## **ADDENDUM No 1 to EOI DOCUMENT**

### ***Miyar Hydro Electric Project Works Packages Lot MHEP CWI/II/III/IV & HMI/II***

*Miyar Hydro Electric Power Company Limited (MHEPCL)* hereby informs applicants of the following amendments issued on 07<sup>th</sup> July 2011:

71.1844.00.004 PROJECT AREA GENERAL LAYOUT LONGITUDINAL SECTION

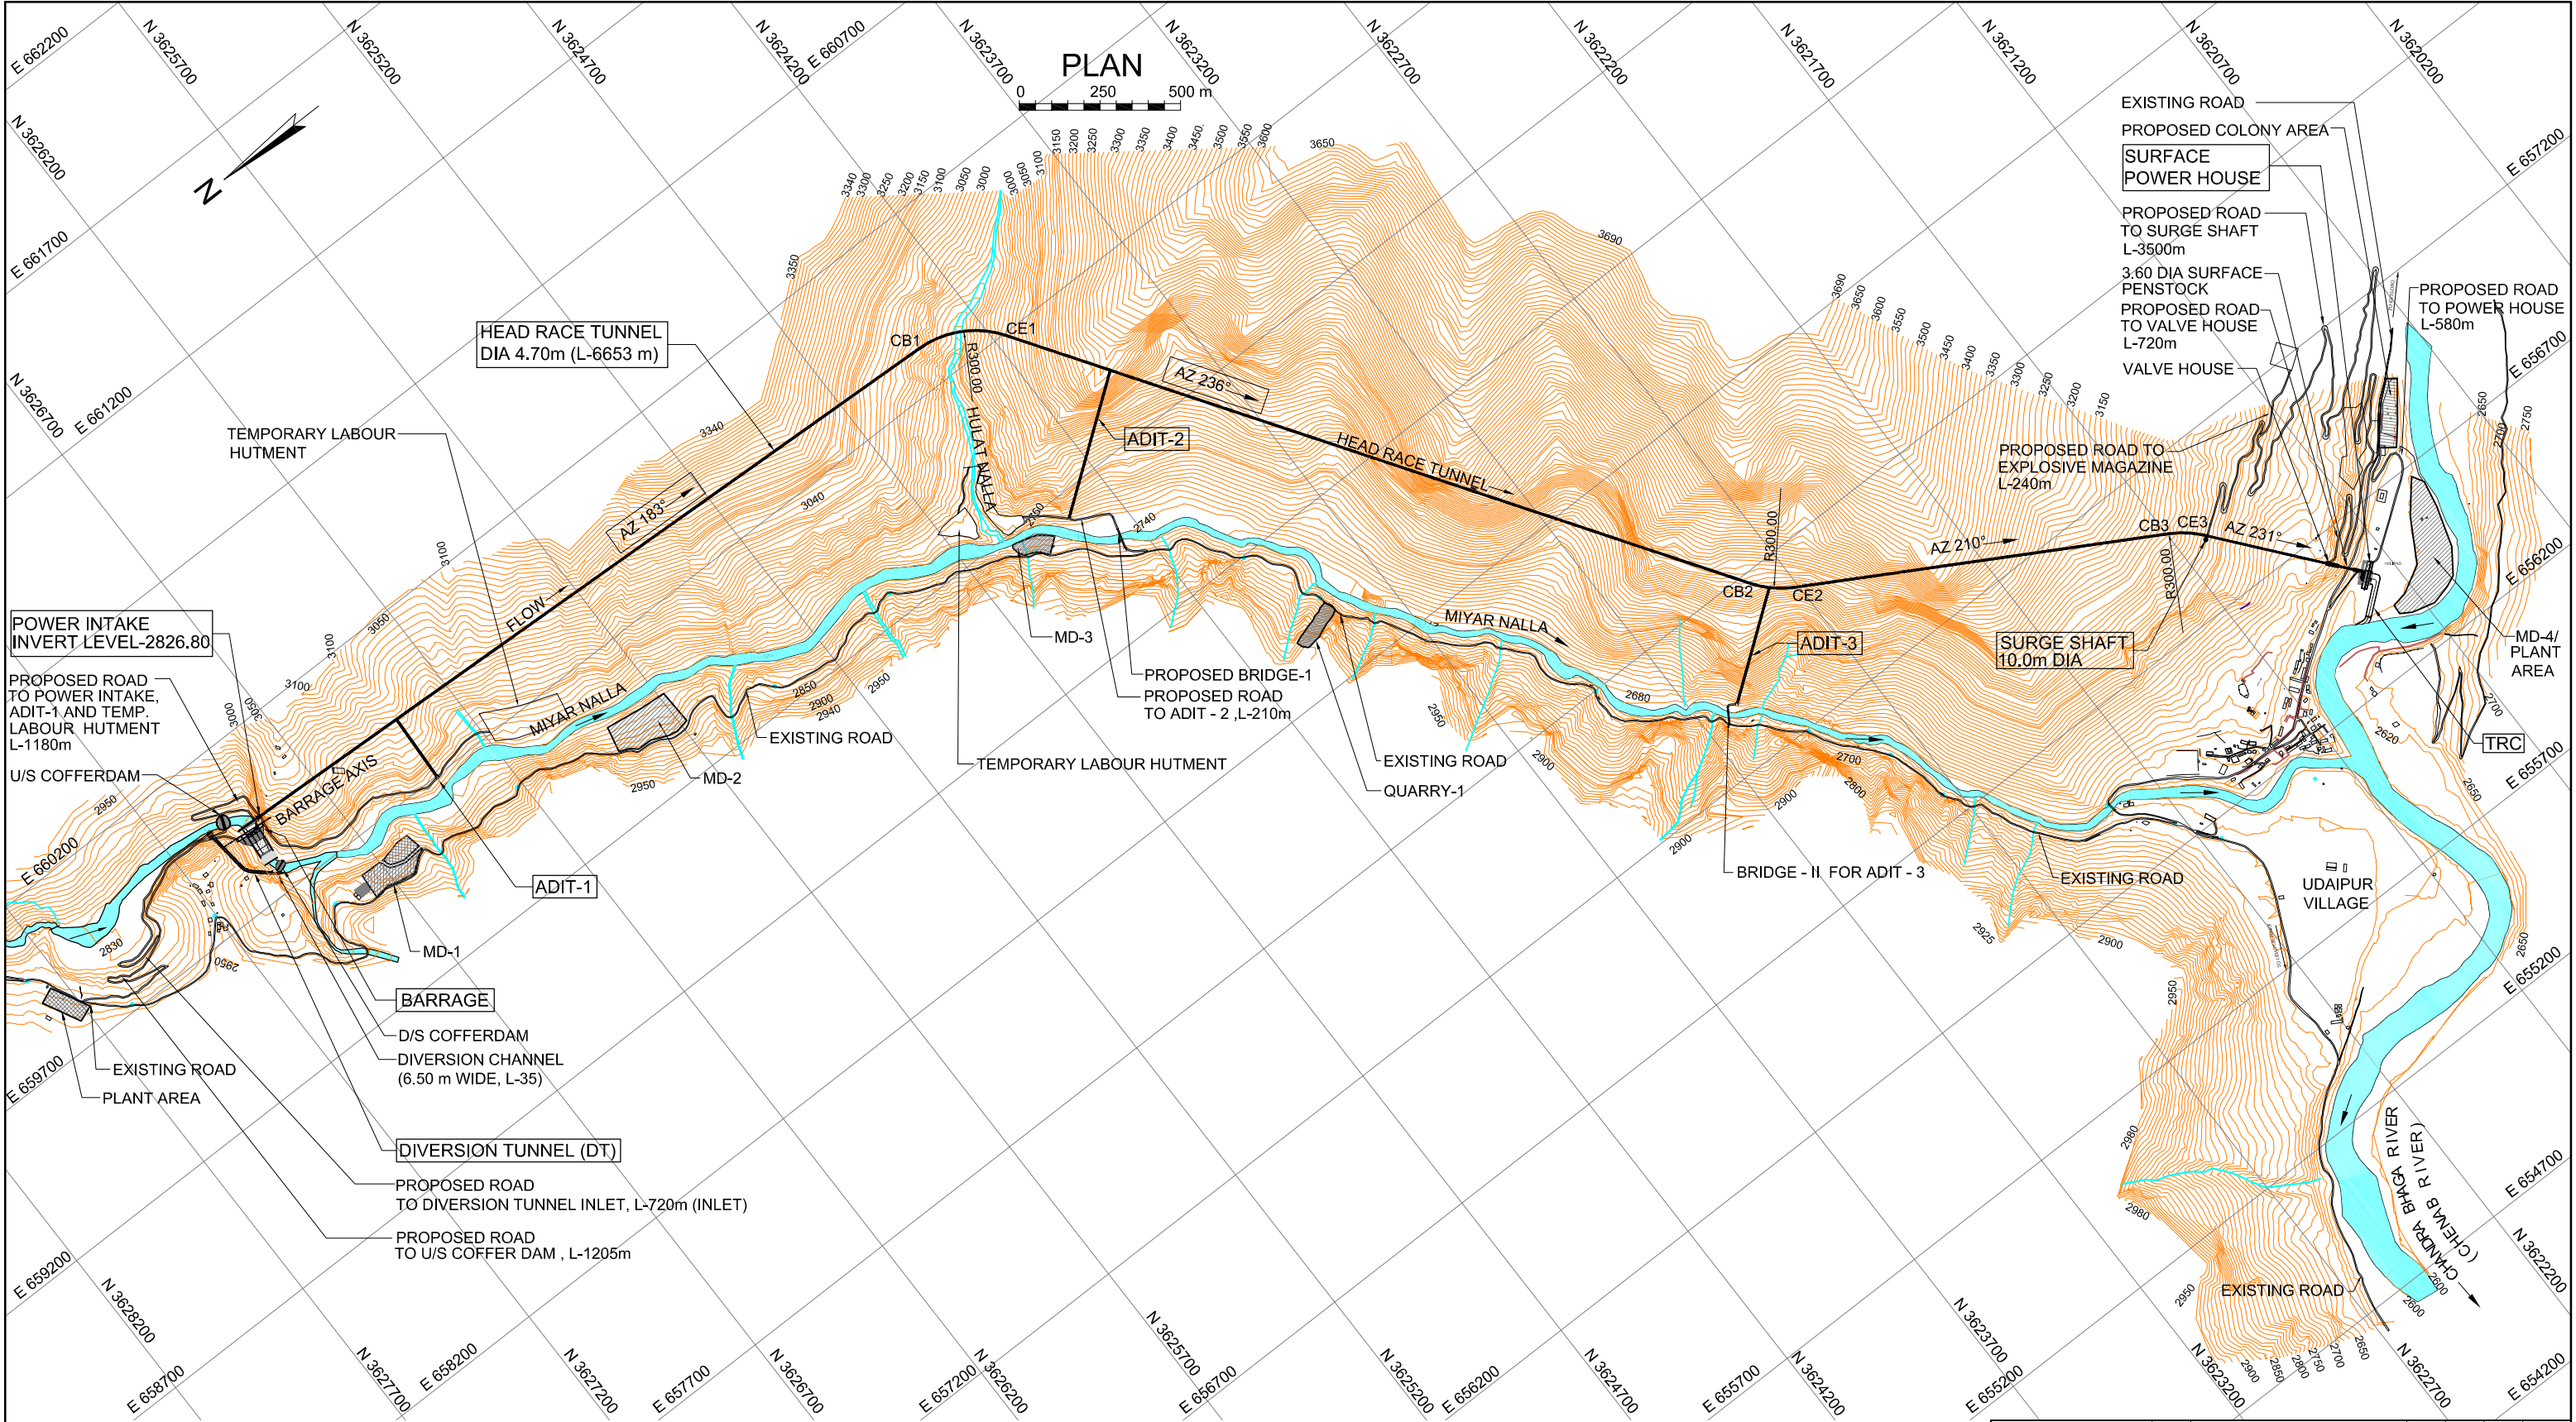
<b>EOI Document</b>	<b>Item</b>	<b>Reference Clause</b>	<b>Revision</b>
SECTION I	Preamble & Requirements	Clause No. 1.3 : Project Layout	Add the following after last para: Project Layout drawing is attached in Annexure 1.
SECTION I	Preamble & Requirements	Clause No. 1.7 : Aim & Objective	Amend the clause:  A call to potential contractors to register interest in Civil & Hydro-Mechanical works and to demonstrate their ability to execute the Civil & Hydro-Mechanical works of different packages.  Any interested Applicant who has not meet the proposed qualification requirement as stipulated in Section I clause no. 1.8 may also submit their application of EOI.
SECTION I	Preamble & Requirements	Clause No. 1.8 : Qualification Requirements	Amend the Clause Heading :  Proposed Qualification Requirements for Participating in further Process of Bidding
SECTION I	Preamble & Requirements	Clause No. 1.9 : Letter of Transmittal	Add the following line in the para:  Applicants may submit the application for any or all the packages fulfilling conditions stipulated in EOI document.
